Access Compliance Report

Public Rights-of-Way

Intersection ID: 30545	Main Street: COLONY_RD	Cross Street: STONECROFT_PARK_DR	Location: SW
ADA ID: C091FD84724B	Ramp Type: BlendTrans1	Initial Pass/Fail: Pass	Overall Compliance: No
		Severity Score: 2.5

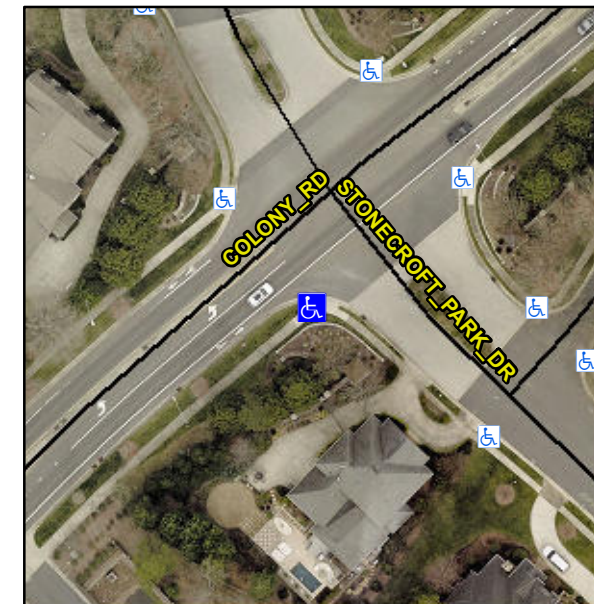
Not Found, R304.2.1, R305.1.4

N/A	Ramp inside XWalk1?	N/A	N/A	Ramp inside XWalk2?	N/A
	Road Slope (%)	1.2		Clear Space?	Yes
	Road X Slope (%)	0.1	N/A	Clear Space to XWalk (in)	N/A
Yes	Any Obstructions?	No	Yes	Storm Grate/Utility Hazard?	No
	Obstruction Type			Storm Grate/Utility Type	
		N/A			N/A
			Yes	Surface Condition? (G/P)	Good
			No	Curb Slope (%)	6.8

Remove & Replace Curb Ramp With Two New Directional Ramps or Equivalent.
